ADDENDUM NO. 5

Reference: New Classroom Building
UVU - Orem, Utah
DFCM Project No. 12192790

ADDENDUM NO. 5
May 22nd, 2013

Utah Valley University Classroom Building
Orem, Utah

A3 SF102B Level 2 Area 'B' Floor Framing Plan

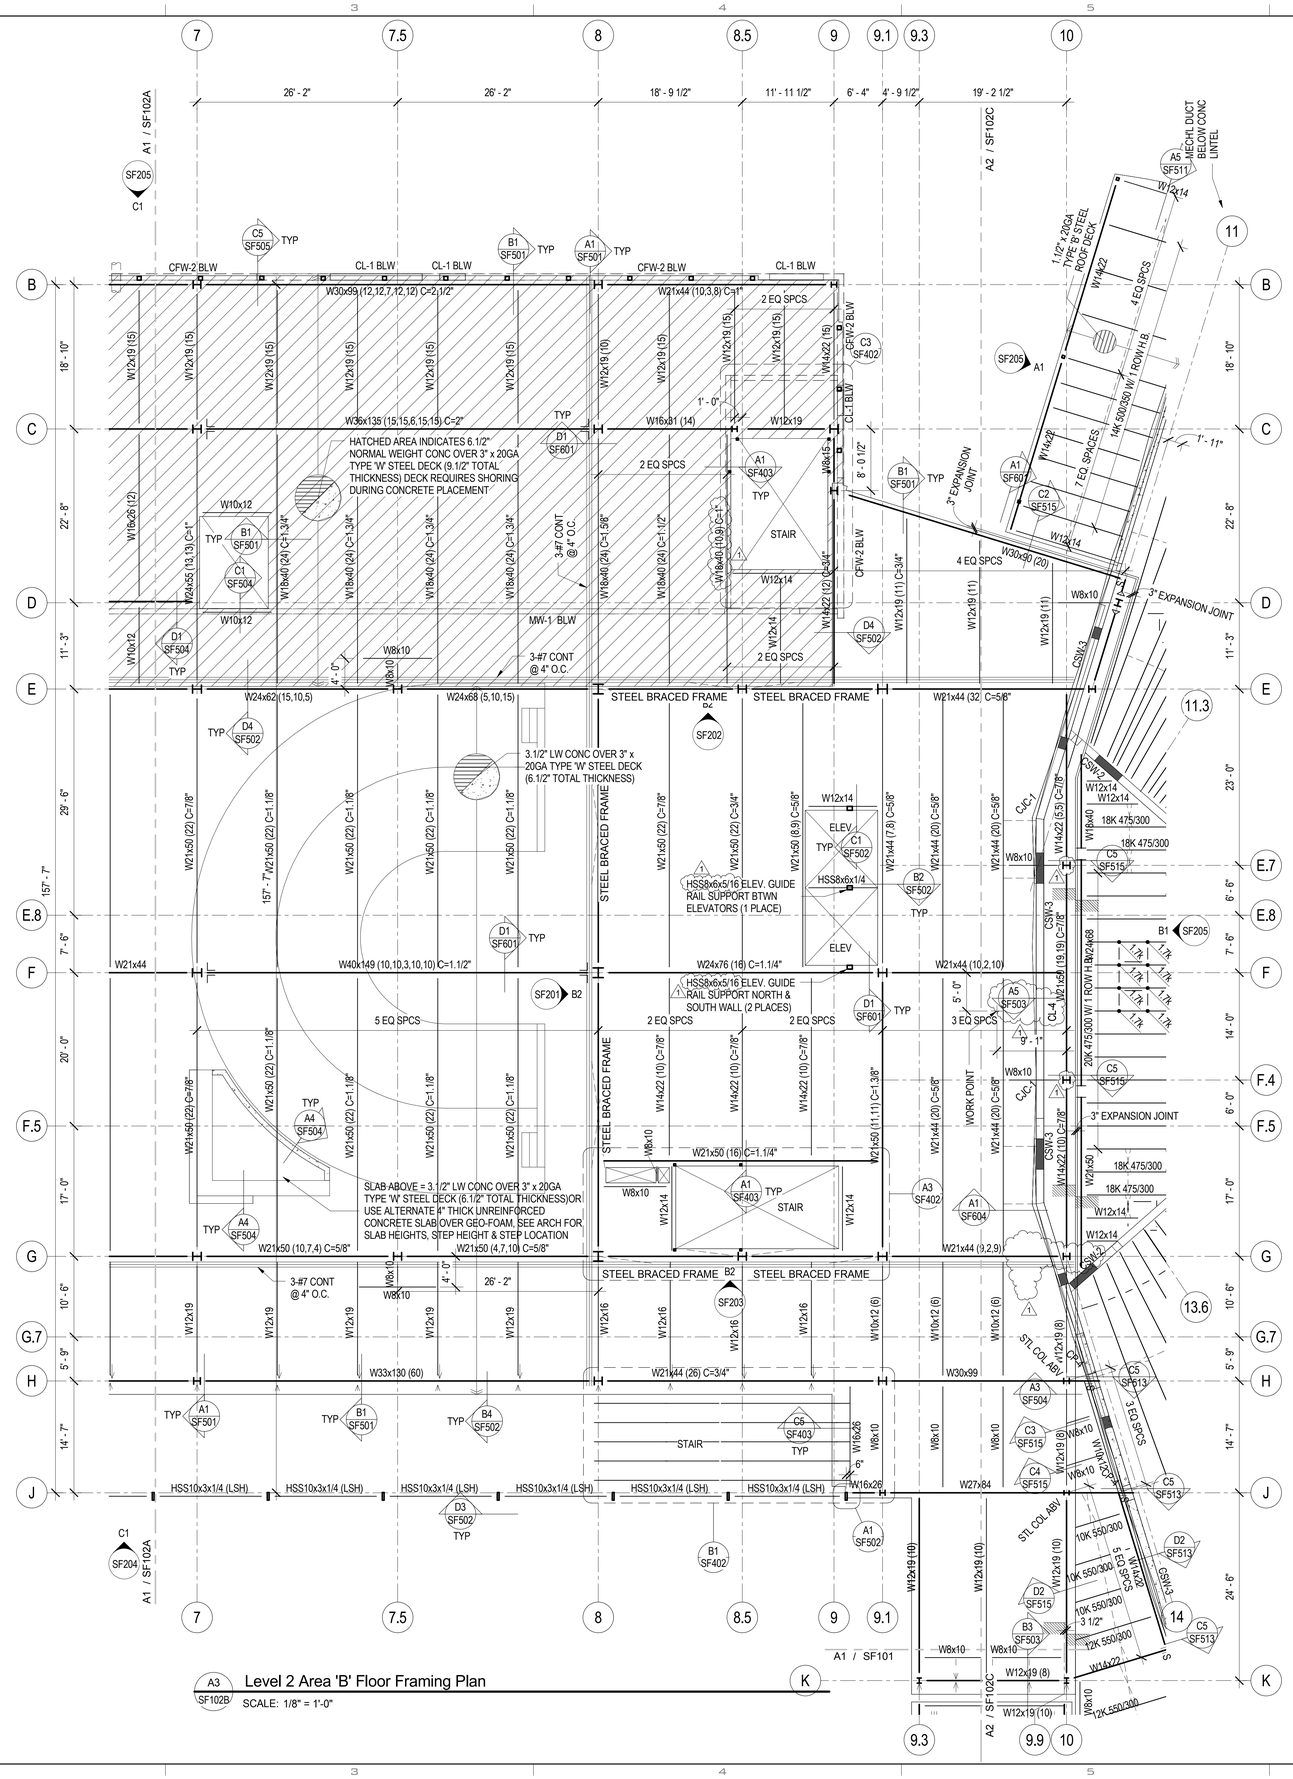
Sheet SF102B
1. Add elevator guide rail support column size. See revised Sheet SF102B.
2. Revise framing member size and HSA quantity for beam along Grid 8.5/C-E. See revised Sheet SF102B.
3. Delete detail cut at Grid G/10. See revised Sheet SF102B.
4. Rotate columns at Grids E.7/10 and F.4/10 90 degrees. See revised Sheet SF102B.

A2 / SF102C Level 2 Area 'C' Roof Framing Plan

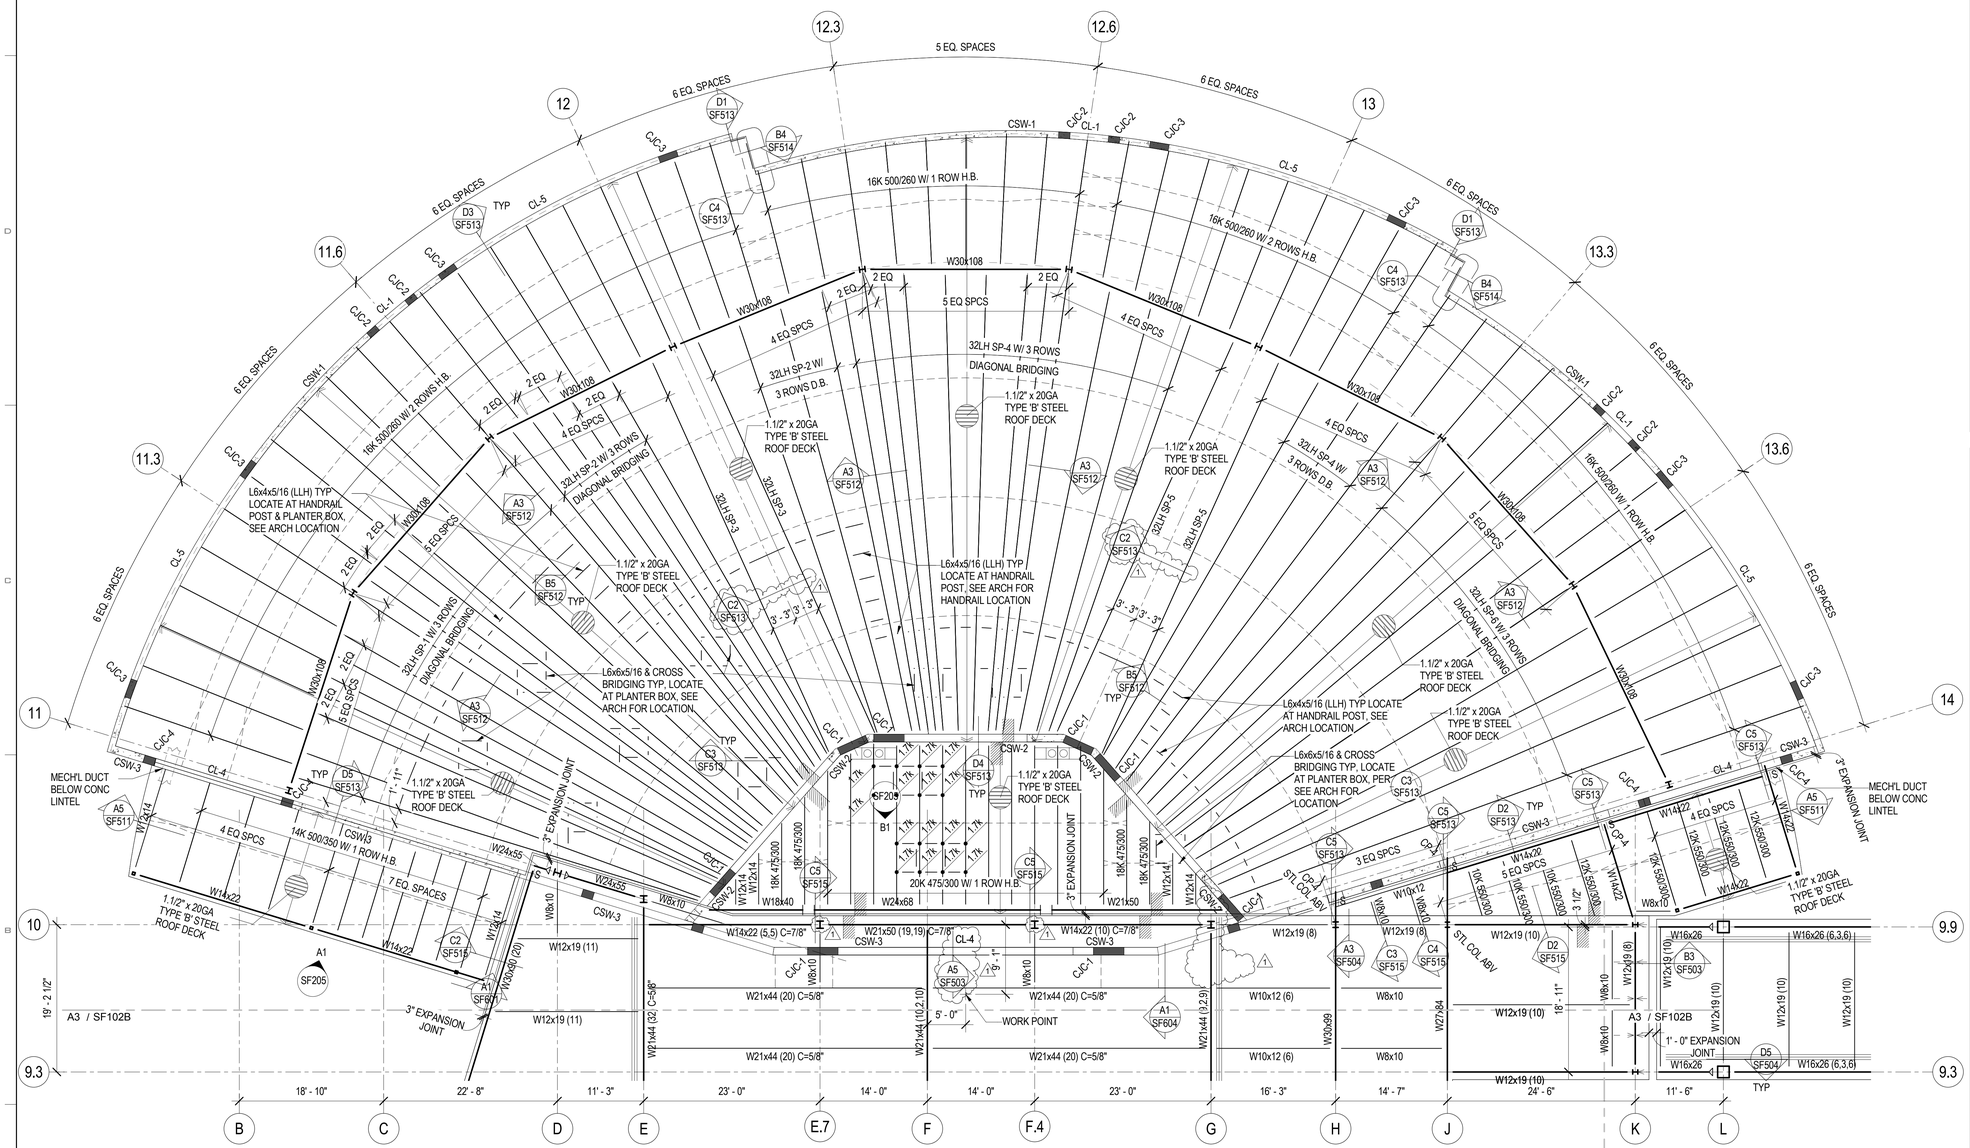
Sheet SF102C
1. Add detail cut A5/SF503 at bench at opening in concrete wall near Grid 10 and between Grids F and F.4. See revised Sheet SF102C.
2. Add detail cut C2/SF513 on Grids 12 and 13. See revised Sheet SF102C.

A3 SF104B Level 4 Area 'B' Floor Framing Plan

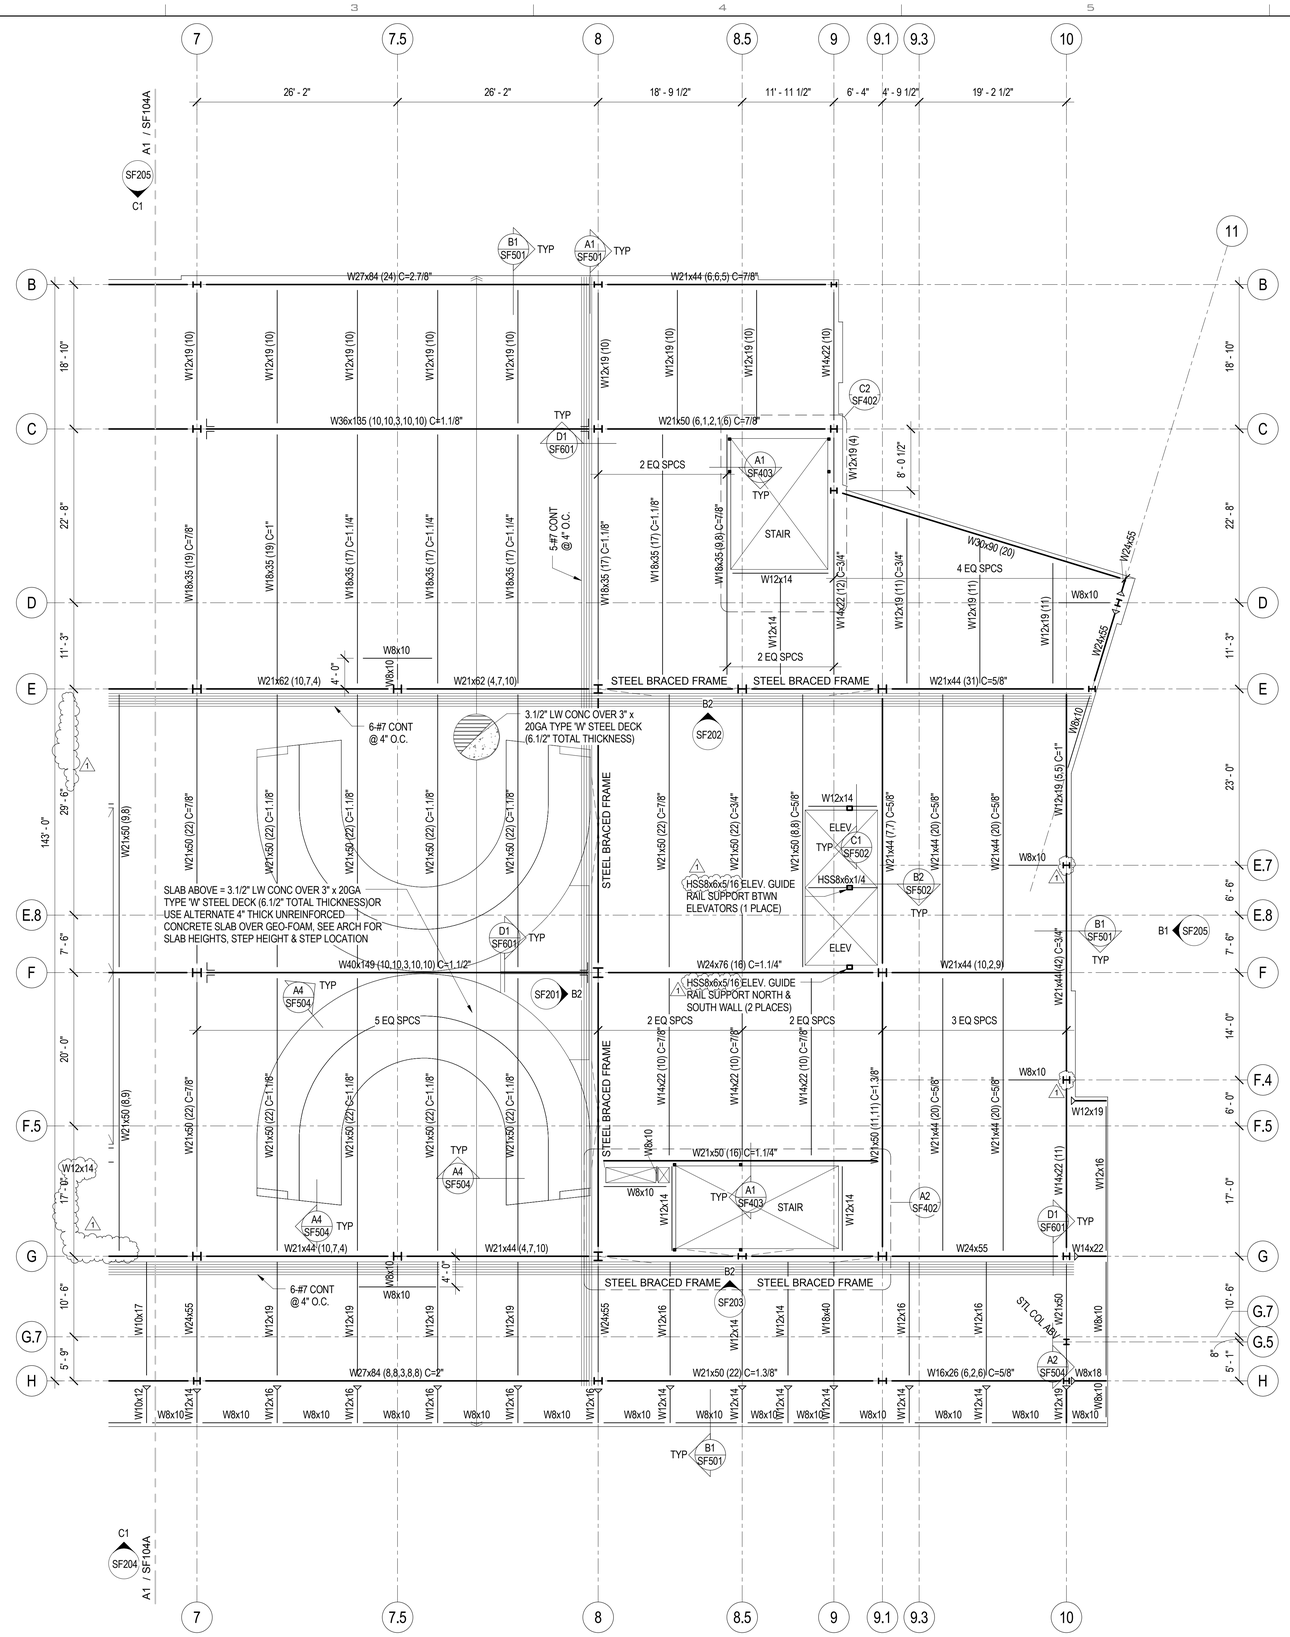
1. Add elevator guide rail support column size. See revised Sheet SF104B.
2. Rotate columns at Grids E.7/10 and F.4/10 90 degrees. See revised Sheet SF104B.

A2 SF105B Level 5 Area 'B' Floor Framing Plan

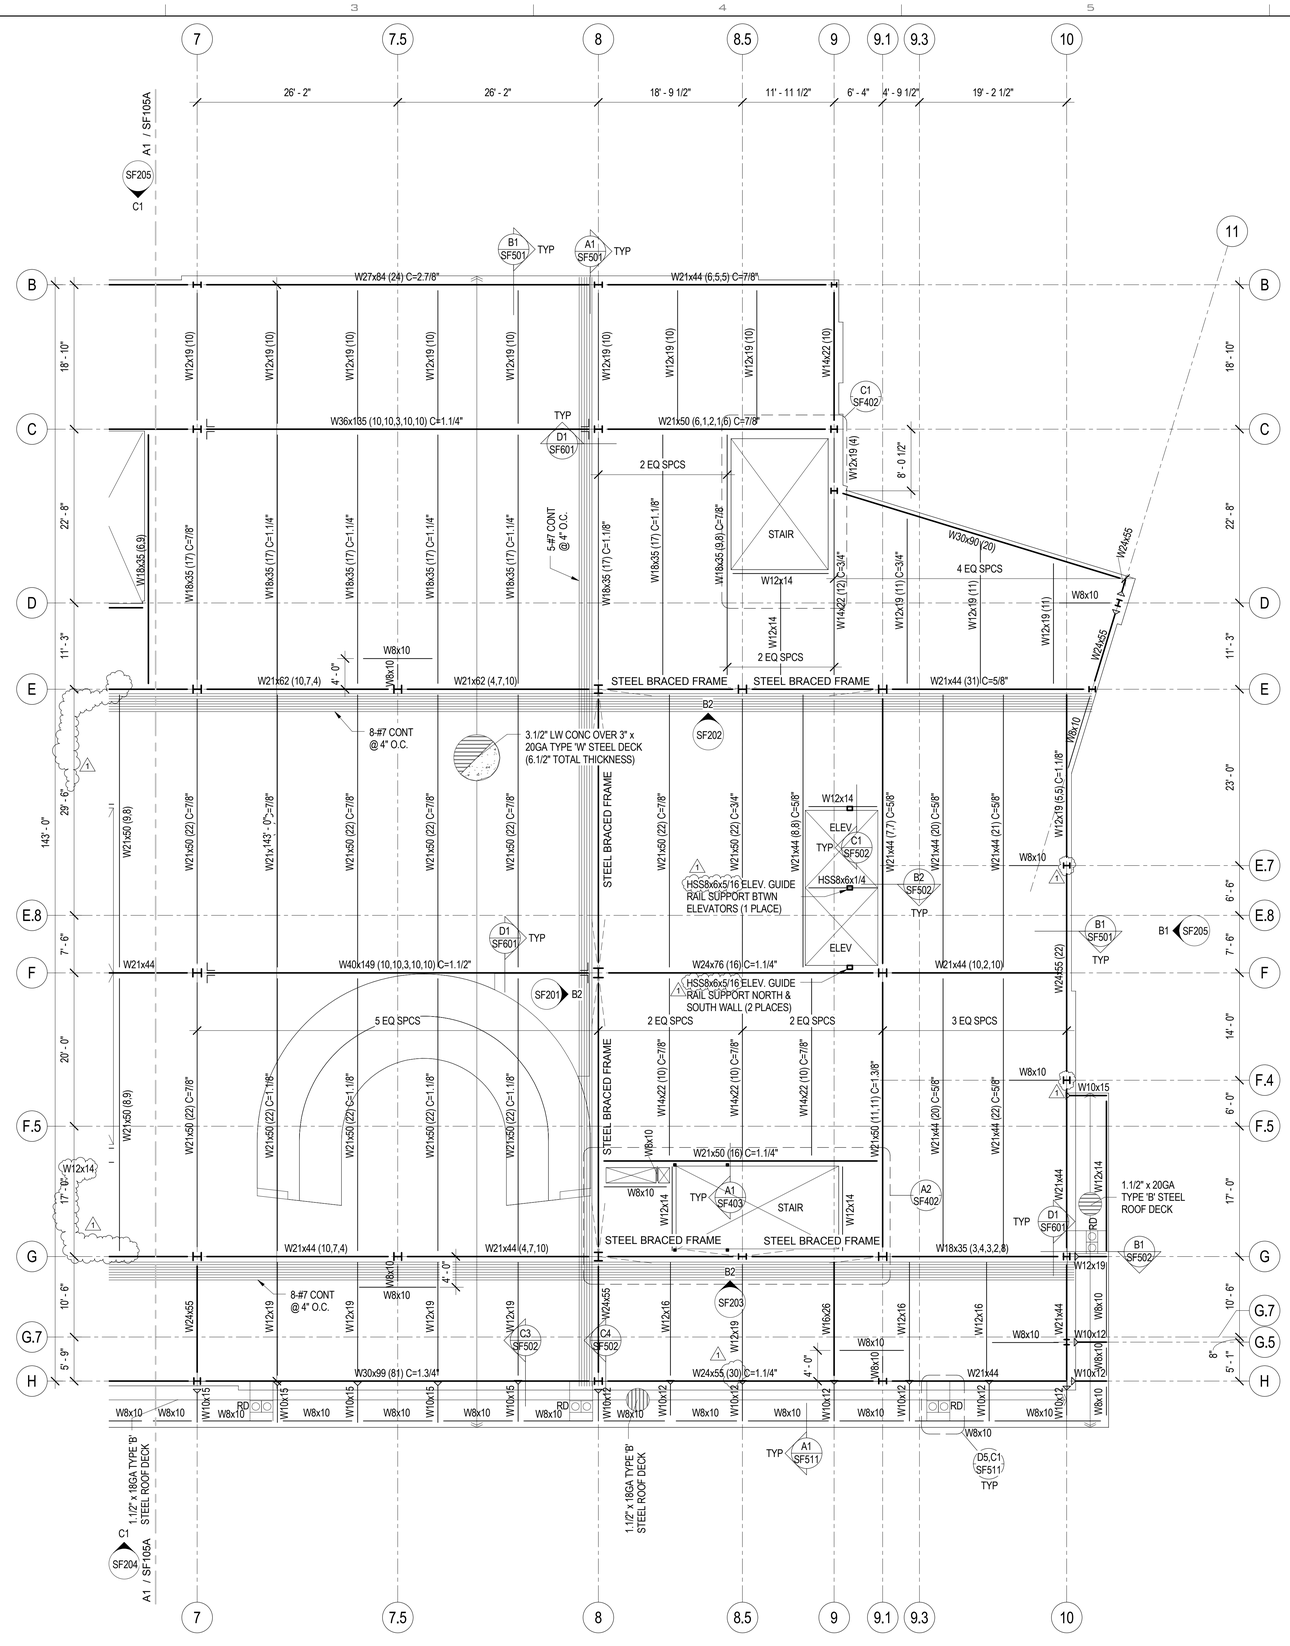
1. Add elevator guide rail support column size. See revised Sheet SF105B.
2. Rotate columns at Grids E.7/10 and F.4/10 90 degrees. See revised Sheet SF105B.

A2 SF106B Level 6 Area 'B' Roof Framing Plan

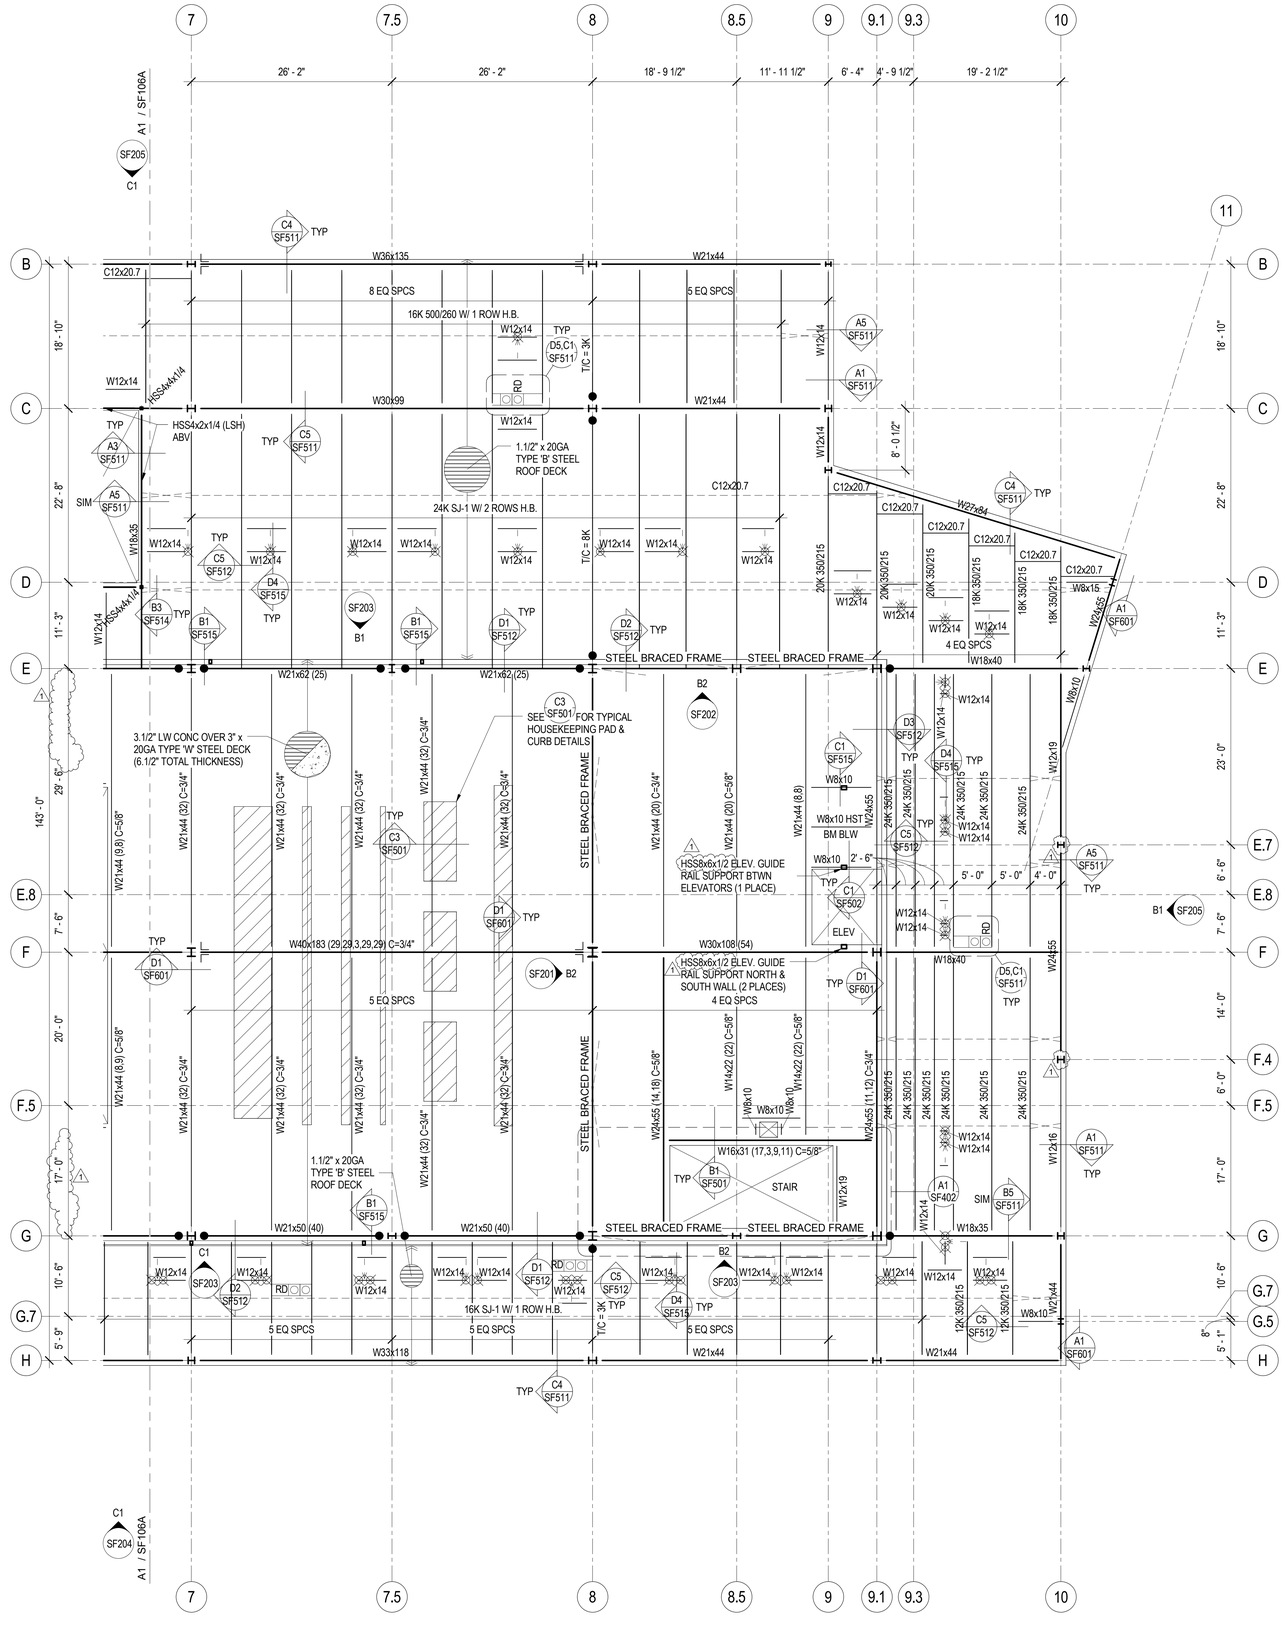
1. Add elevator guide rail support column size. See revised Sheet SF106B.
2. Rotate columns at Grids E.7/10 and F.4/10 90 degrees. See revised Sheet SF106B.
